from
**Southern
Water**

Your ref
AL/49/20/PL

Proposal: Demolition of 2 No existing dwellings & erection of 7 No. dwellings with associated parking, bin store, alterations to the existing access & extension of the existing footway.

Site: AL/49/20/PL: - Byfields & Nightingale Cottage, Nylon Road, Westergate, PO20 3US.

Southern Water MapGuide Browser

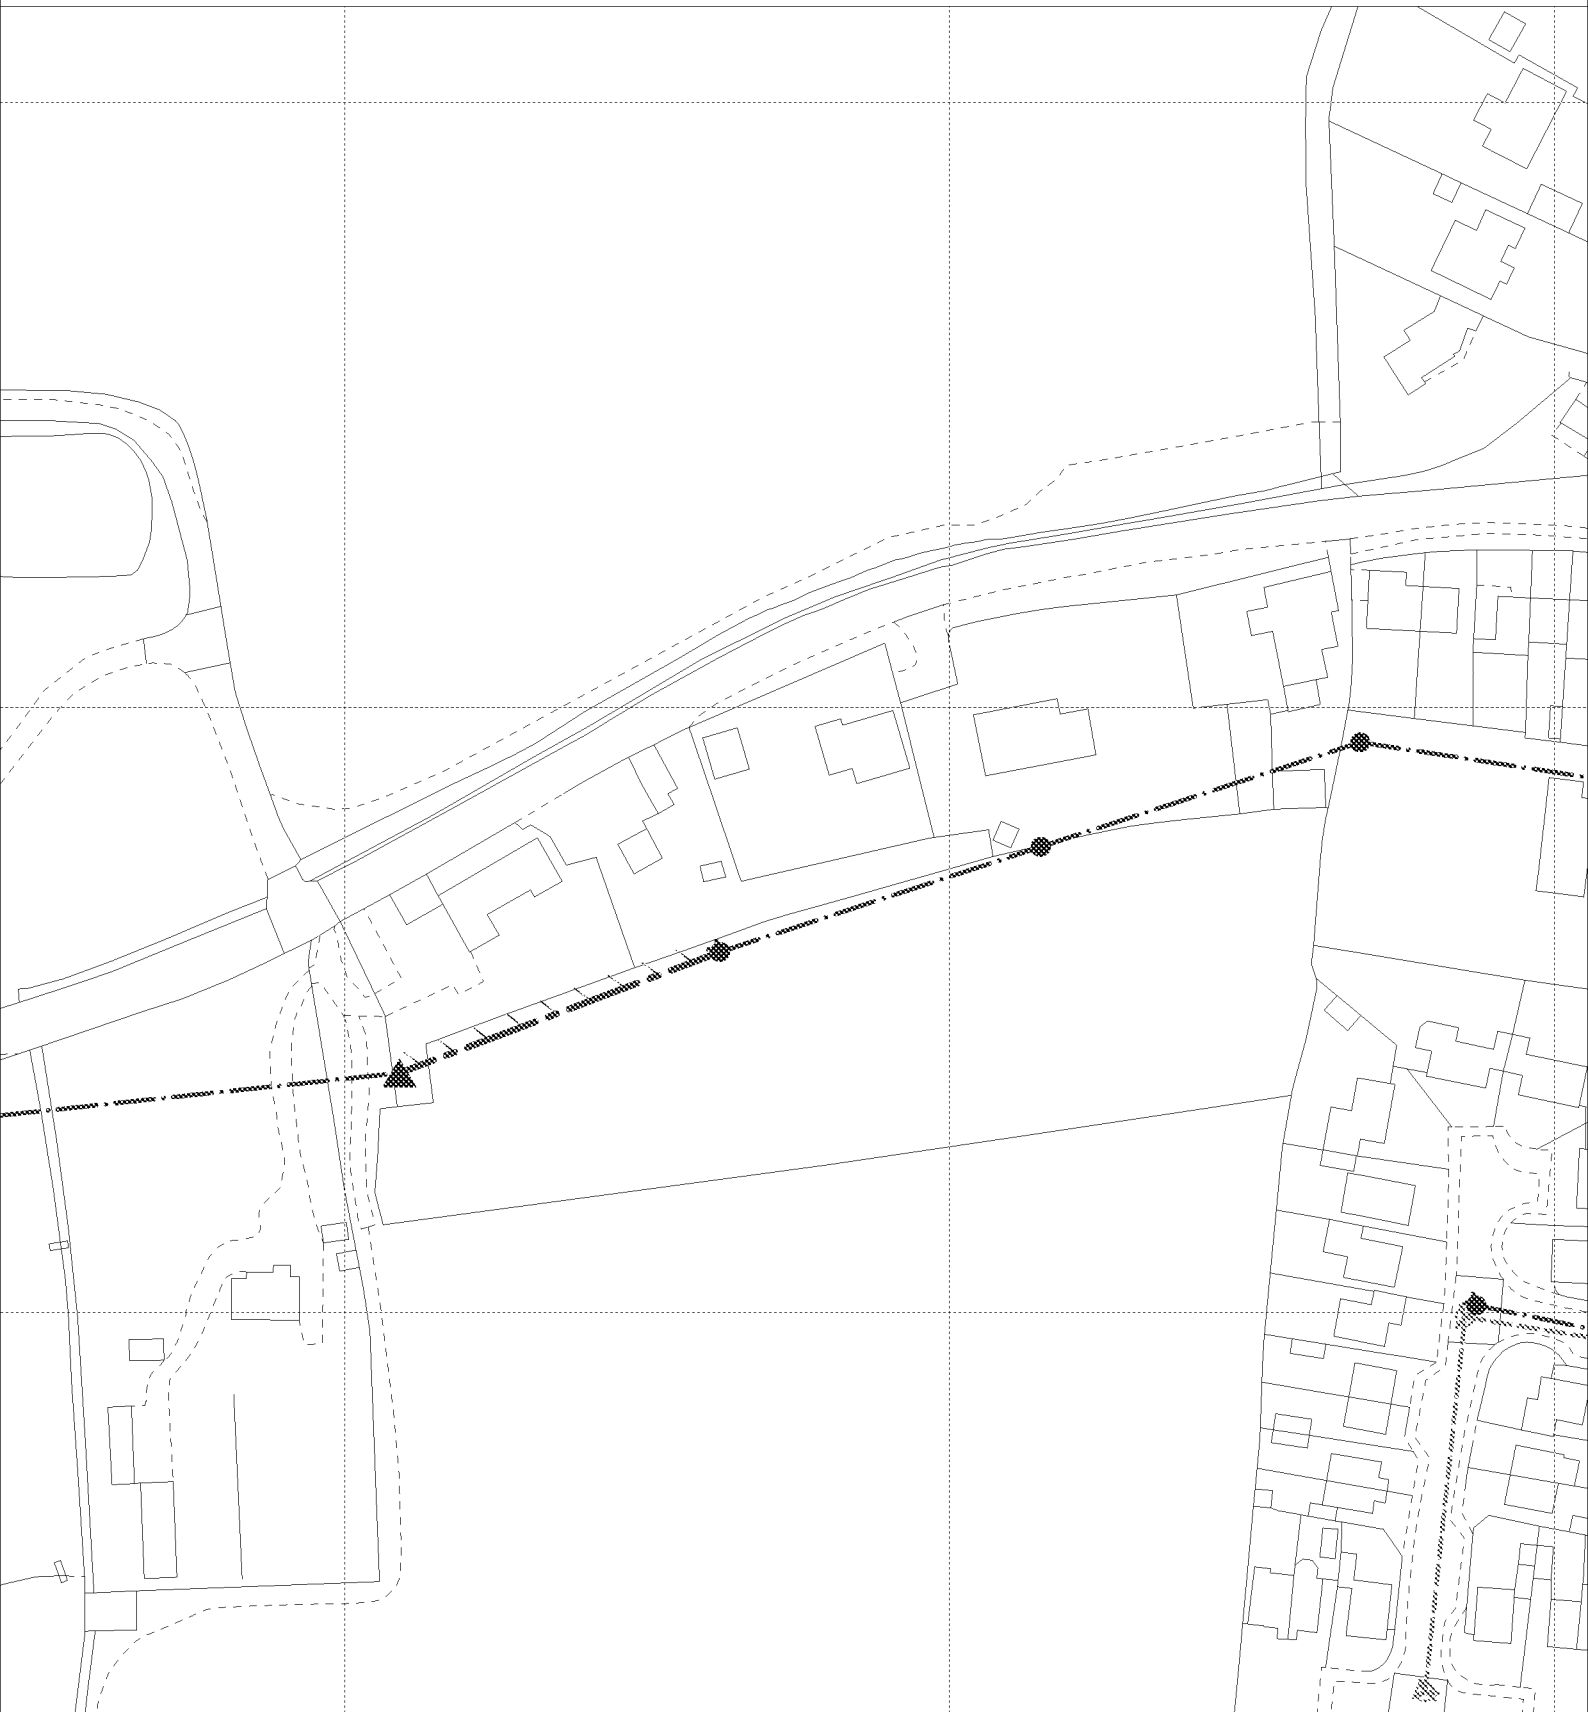
Please find attached a plan of the sewer records showing the approximate position of public foul sewer within the site. The exact position of the public sewers must be determined on site by the applicant before the layout of the proposed development is finalised.

- The 150 mm public foul sewer requires a clearance of 3 metres on either side of the gravity sewer to protect it from construction works and to allow for future access for maintenance.
- No development or tree planting should be carried out within 3 metres of the external edge of the public gravity sewer without consent from Southern Water.
- No soakaway, swales, ponds, watercourses or any other surface water retaining or conveying features should be located within 5 metres of a public sewer.
- All existing infrastructure should be protected during the course of construction works.
